ASIC/1-6000 Floating Actuator Problem

Affects: ASIC/1-6000, -PD, -MB, -MB-PD

Date: 20 June 2008

Note No. TN-040

Older processor P89C

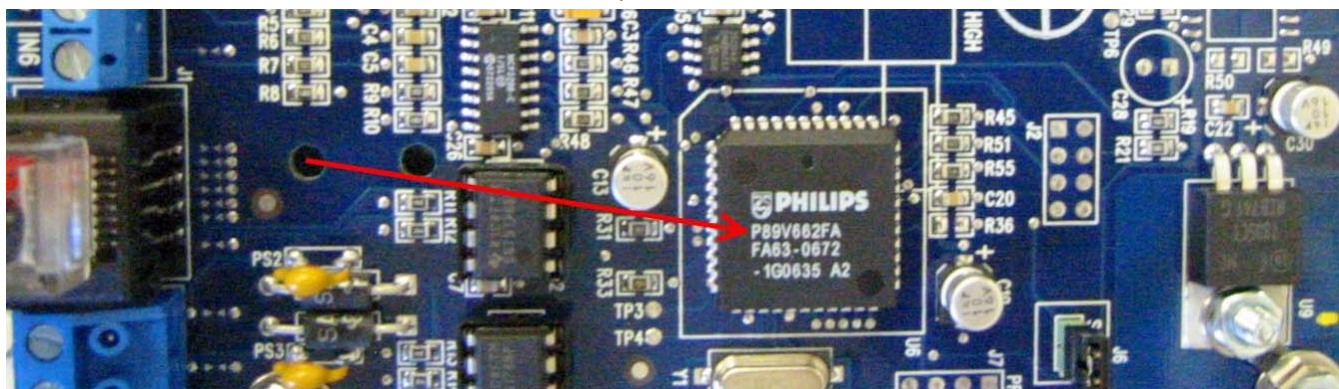
We began shipping a portion of ASIC/1-6000 controllers with a newer ("green"), lead-free processor subsequent to February 1, 2008. The newer processor can be identified by looking at the Philips P89 chip on the circuit board (U6). Chips beginning with "P89V" are the newer "green" processors; chips beginning with "P89C" are the older processors. Two images are provided below to help you identify which processor your controllers uses. Our testing has not found any problems with the P89C processors.
